RE: Request for Amendment to Order of Conditions for DEP#204-0991,
The Reconstruction of Foster Street, MassDOT Project #609054
Littleton, MA.

FOSTER STREET PLAN MARKUPS
SHOWING PROPOSED LOCATION OF 100FT LONG CRUSHED STONE DIAPHRAGM TRENCH AT EDGE OF ROAD
DEP#204-0991
MASSDOT PROJECT 609054

STORMWATER STORAGE VOLUME  
CALCULATIONS  
EQUIVALENCY BETWEEN 4 LEACHING CATCH  
BASINS AND A 100FT LONG CRUSHED STONE  
DIAPHRAGM TRENCH

STATE	FED. AID PROJ. NO.	SHEET NO.	TOTAL SHEETS
MA	STP/CMQ/TAP-0033(037)X	E5	128
PROJECT FILE NO.		609054

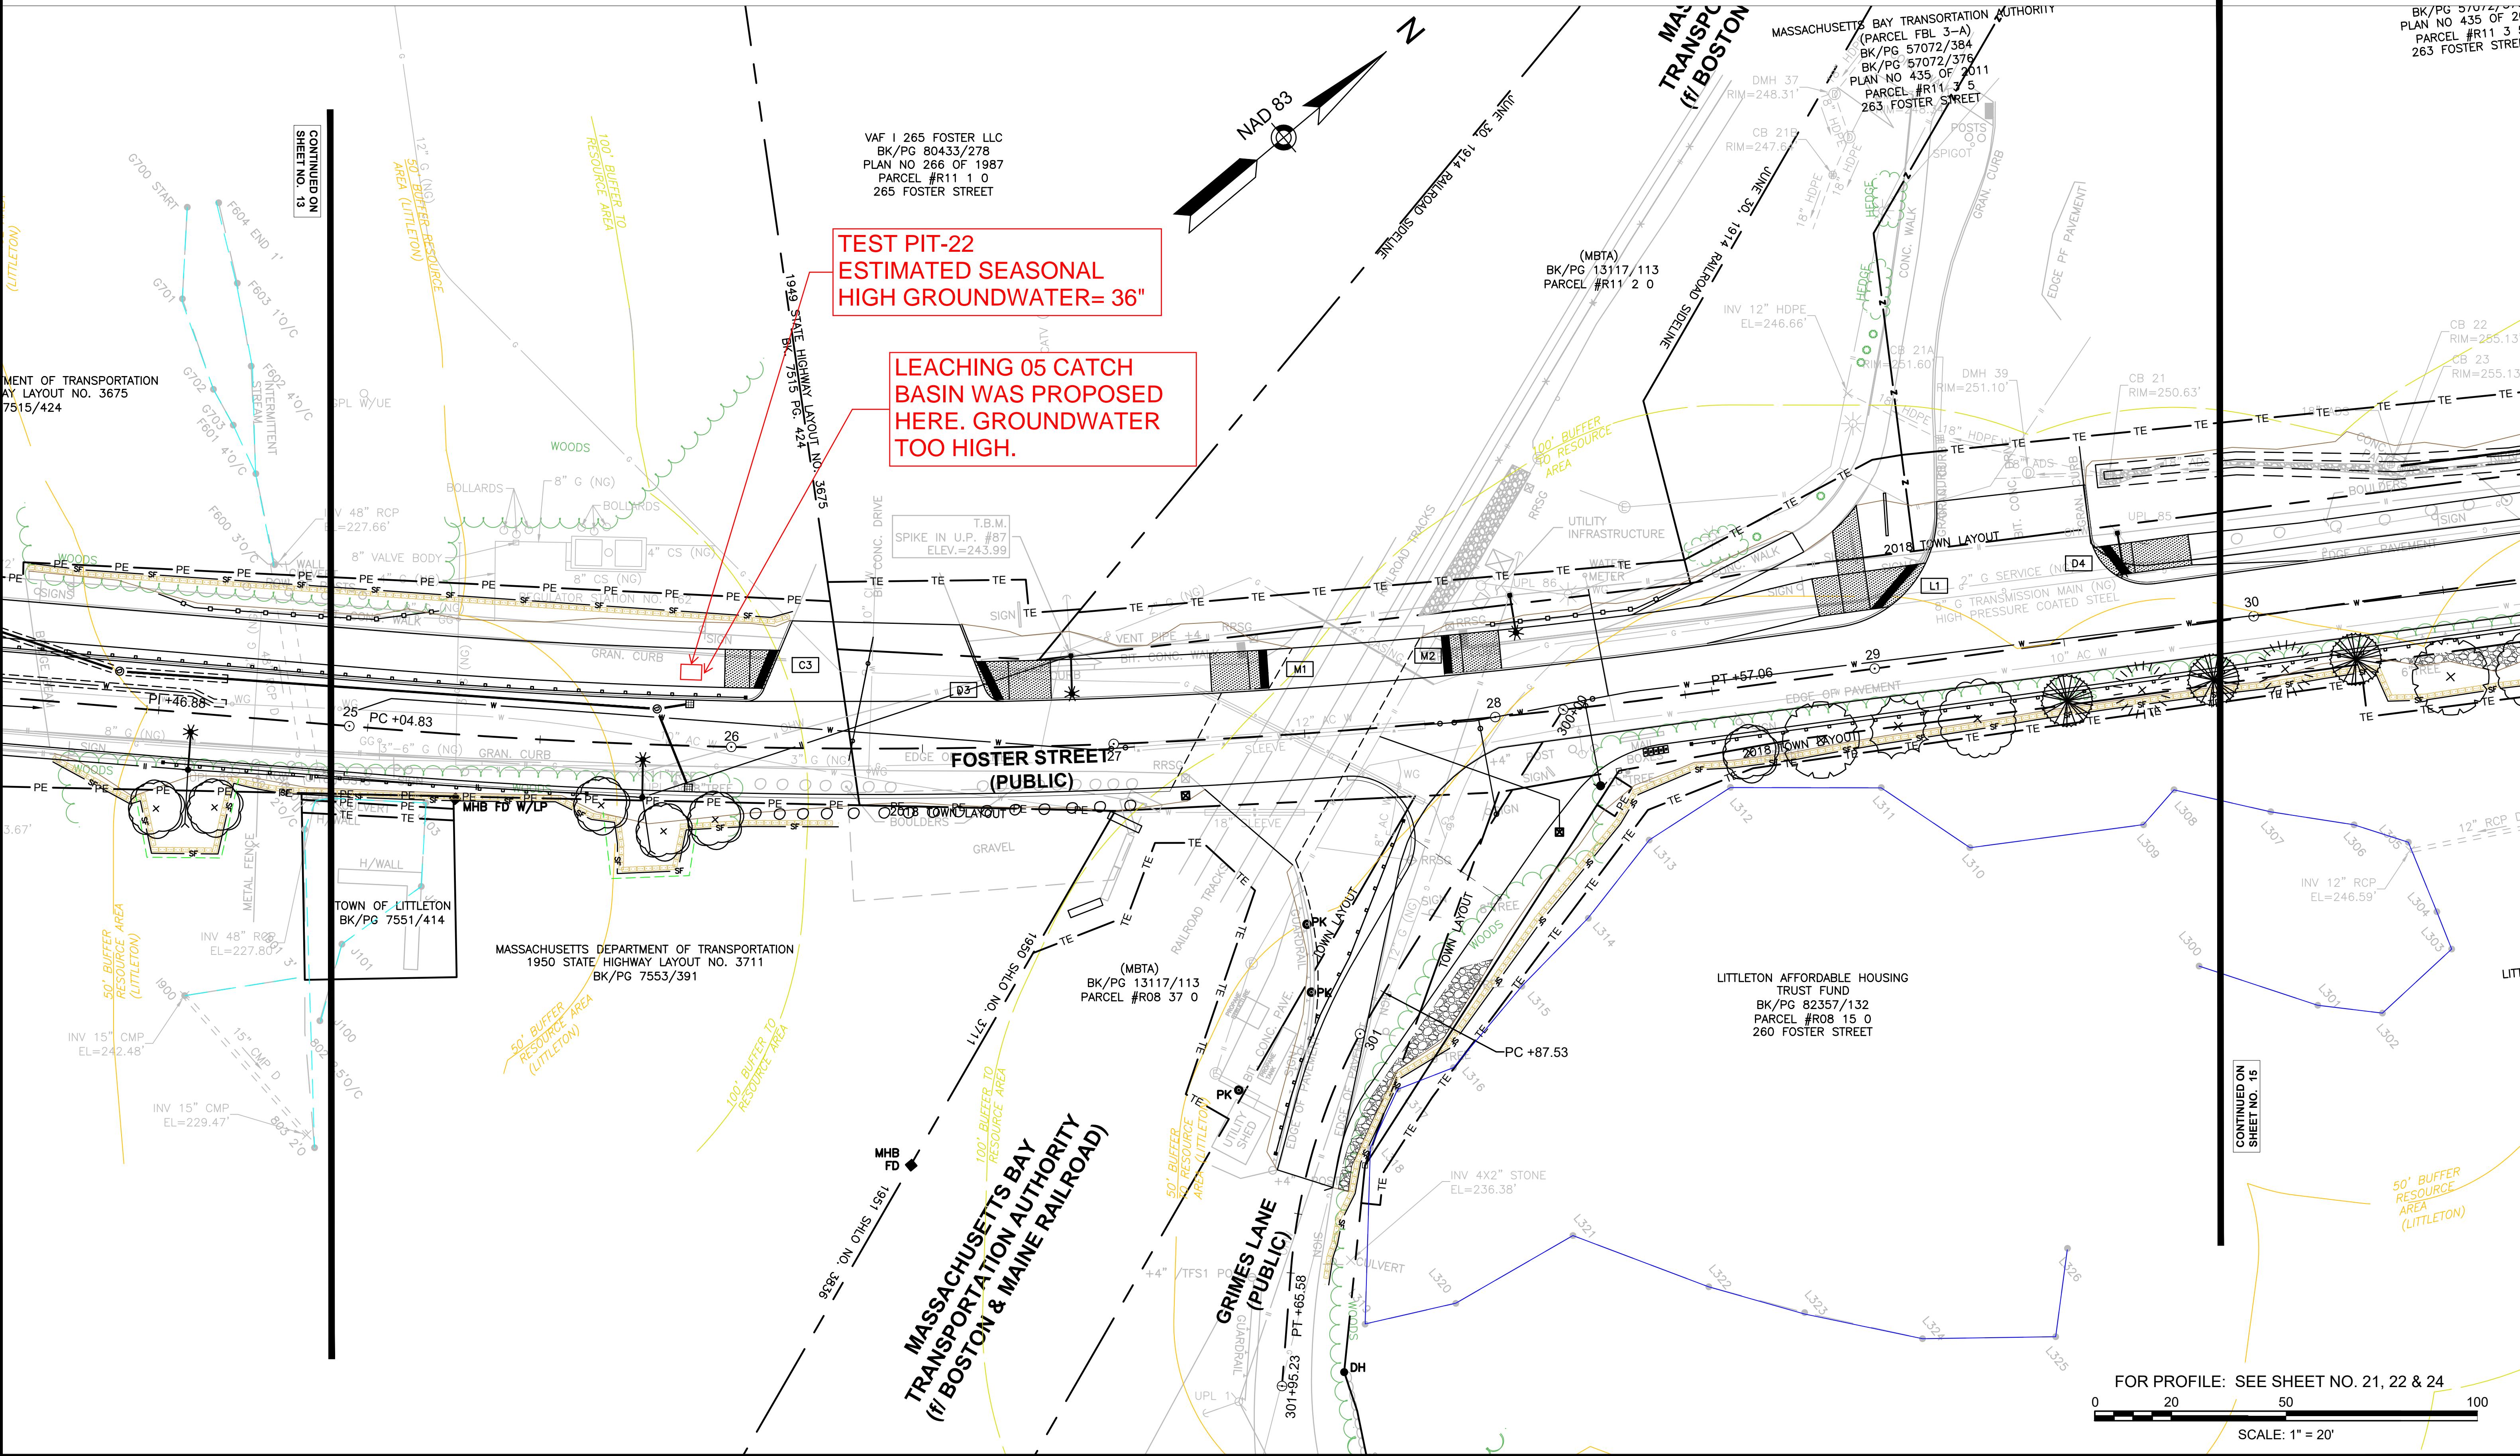
TEST PIT-24
ESTIMATED SEASONAL HIGH GROUNDWATER= 34"

LEACHING 04 CATCH BASIN WAS PROPOSED HERE. GROUNDWATER TOO HIGH.

STATE	FED. AID PROJ. NO.	SHEET NO.	TOTAL SHEETS
MA	STP/CMQ/TAP-0033(037)X	E8	128
PROJECT FILE NO. 609054

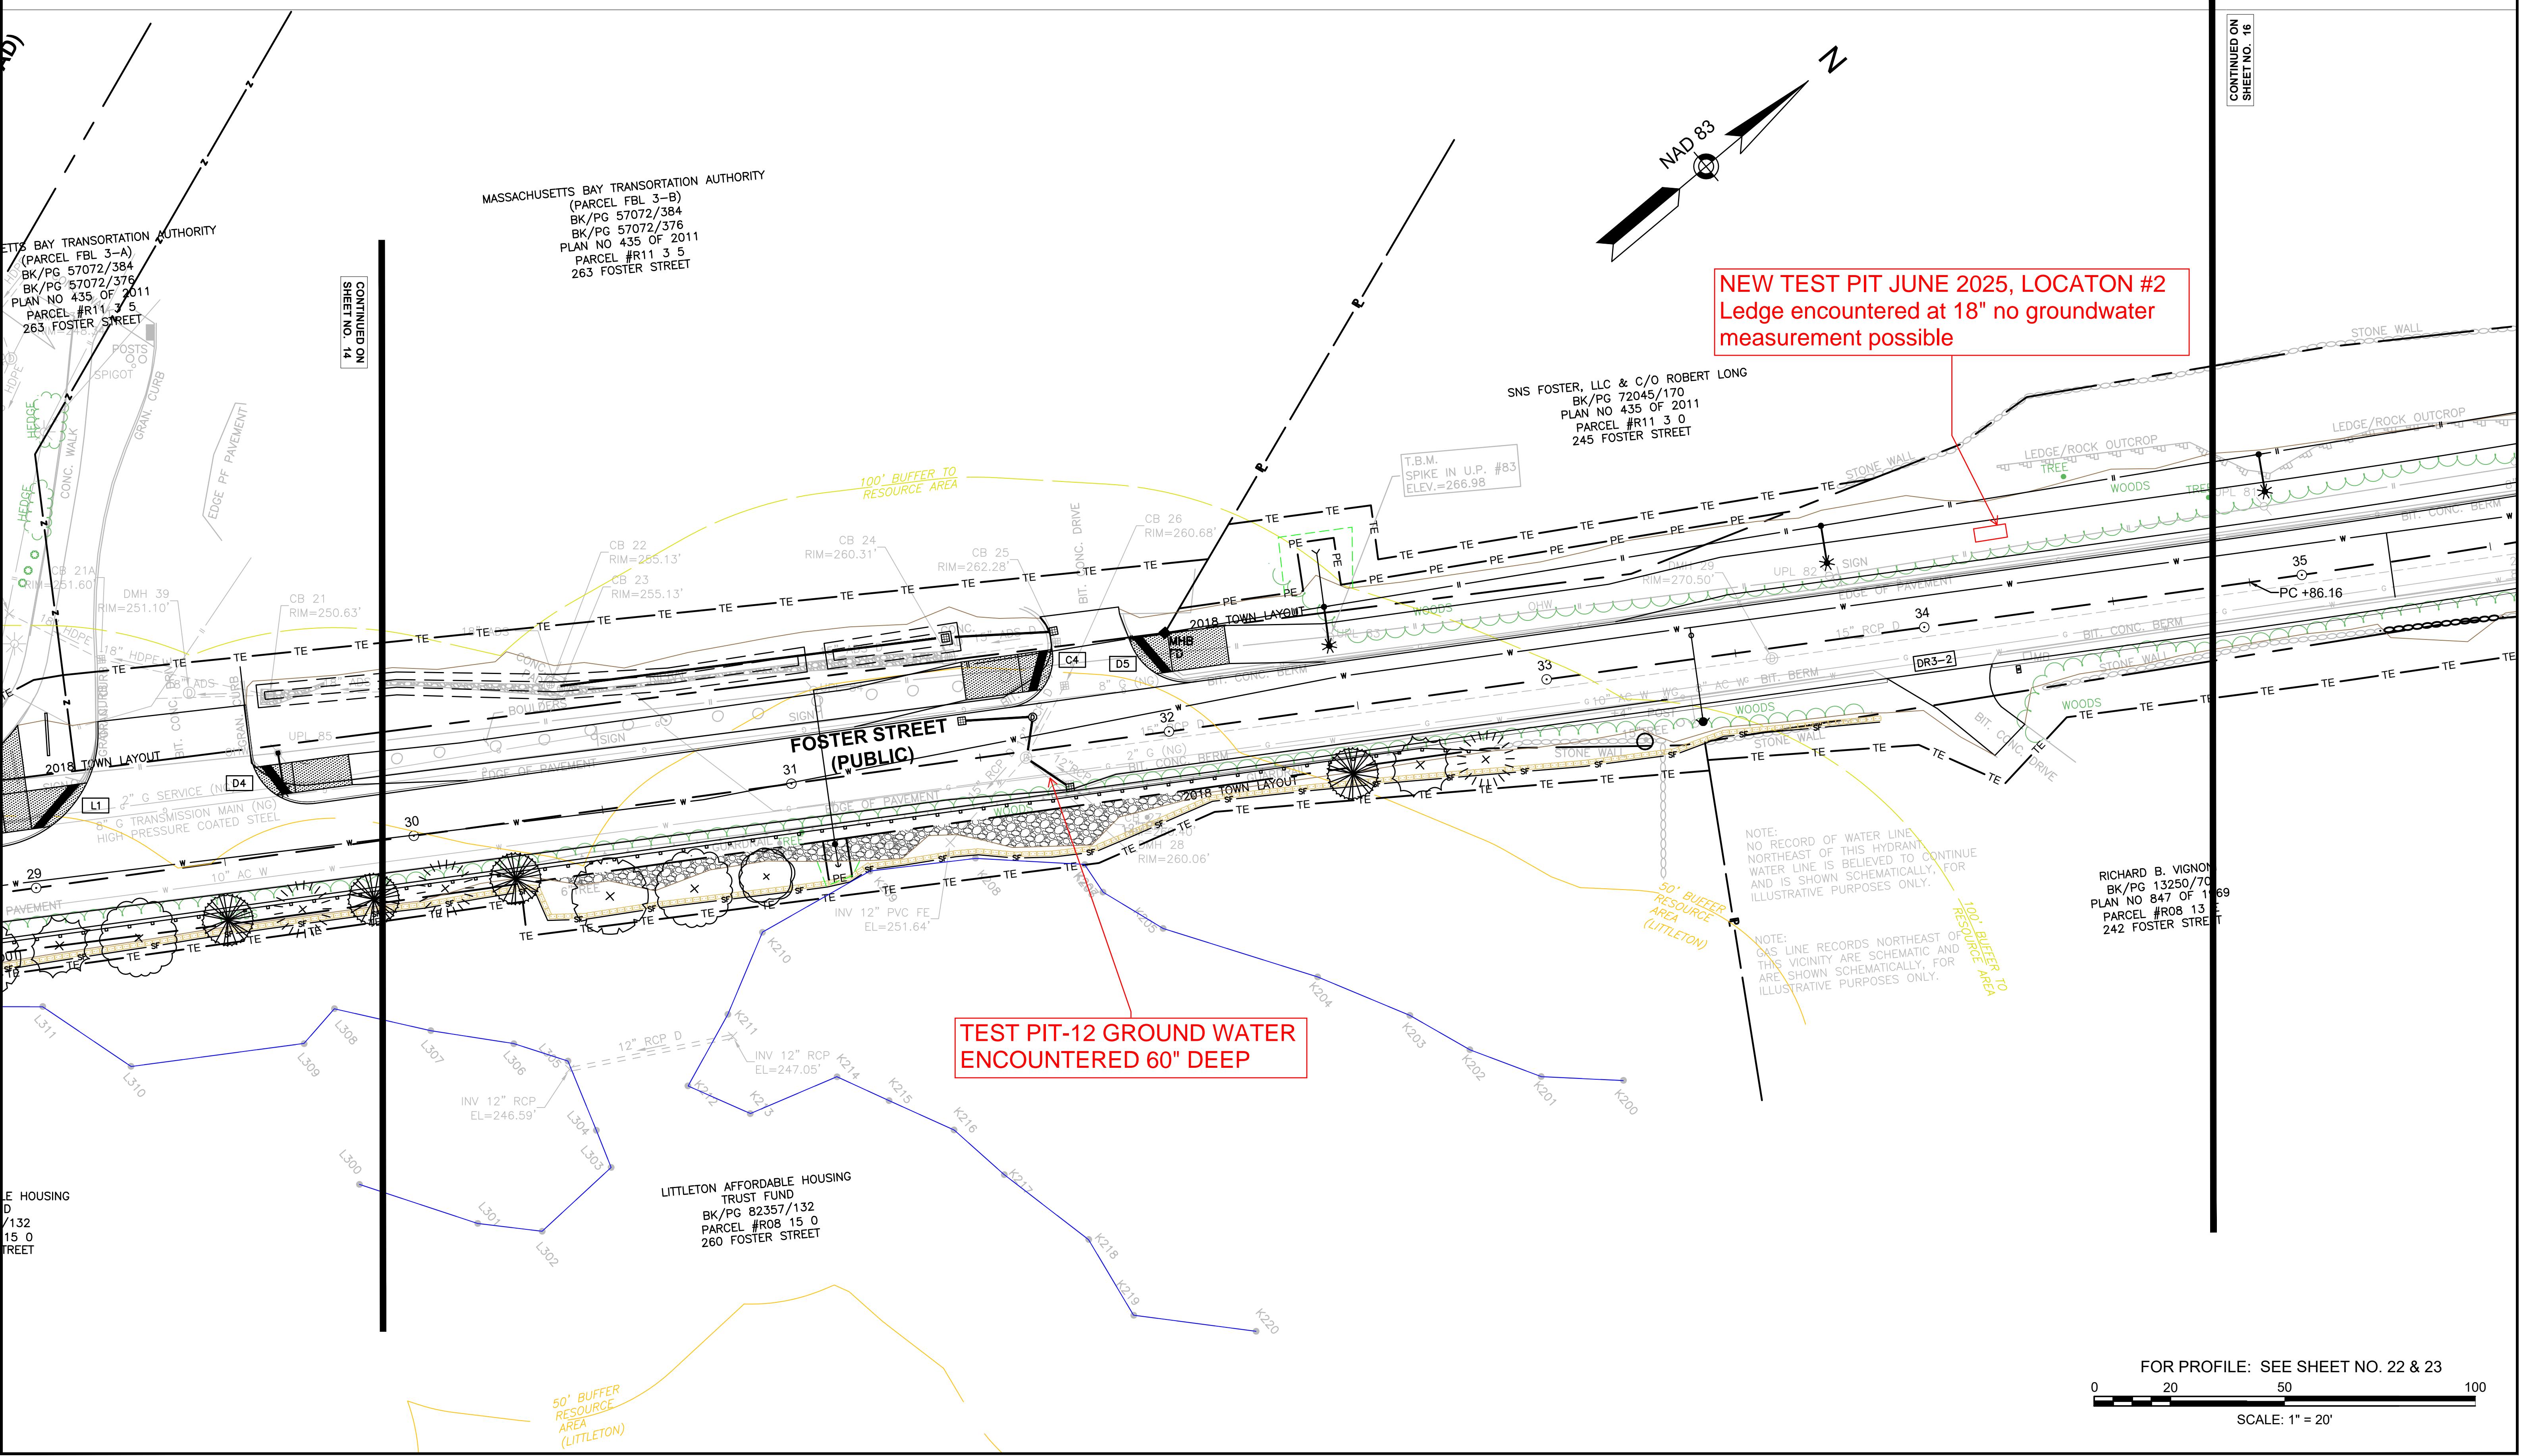
NEW TEST PIT JUNE 2025, LOCATION #3
Ledge encountered at 36" no groundwater measurement possible

TEST PIT-33 ESTIMATED SEASONAL HIGH GROUNDWATER= 108"

NEW FULL-SIZE LEACHING CATCH BASIN INSTALLED HERE
